CITY OF FORT LAUDERDALE

DEVELOPMENT REVIEW COMMITTEE

CASE COMMENT REPORT

CASE:	UDP-S23067
MEETING DATE:	January 09, 2024
REQUEST:	Site Plan Level II Review: 345 Multifamily Residential Units with 3,645 Square-Feet of Commercial Use
APPLICANT:	501 NE Holdings, L.P.
AGENT:	Andrew Schein, Lochrie & Chakas, P.A.
PROJECT NAME:	Flagler Village Residences
PROPERTY ADDRESS:	500 NE 3rd Avenue
ZONING DISTRICT:	Regional Activity Center - City Center District (RAC-CC)
LAND USE:	Downtown Regional Activity Center
COMMISSION DISTRICT:	2 – Steven Glassman
NEIGHBORHOOD ASSOCIATION:	Flagler Village Civic Association
CASE PLANNER:	Tyler Laforme

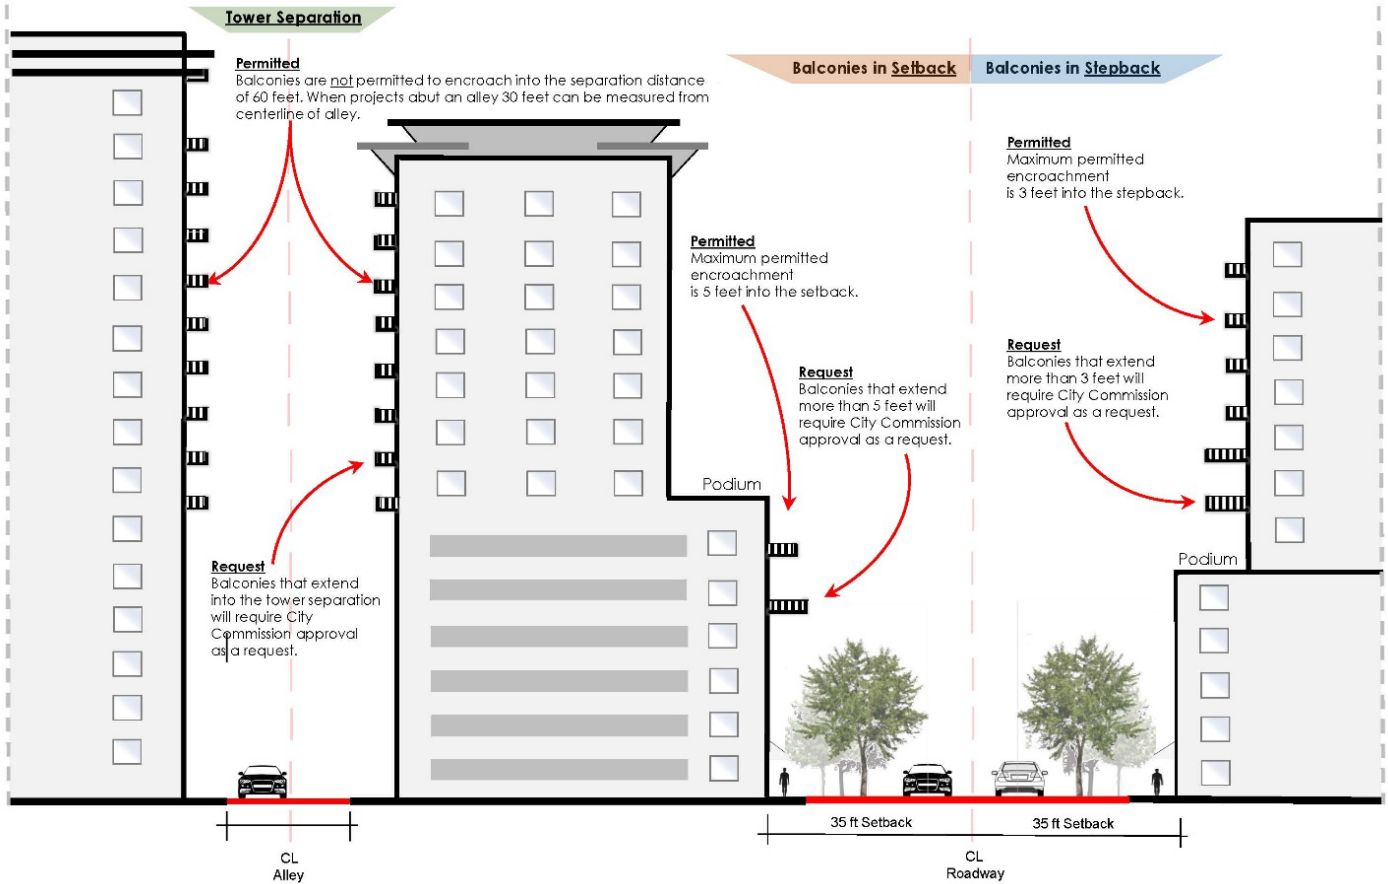
- h. B20) Balconies cannot encroach within the tower separation, as shown on sheet A2.06. See Exhibit A at the end of the document for specific dimensional requirements. Encroachment into the tower separation requires City Commission approval.
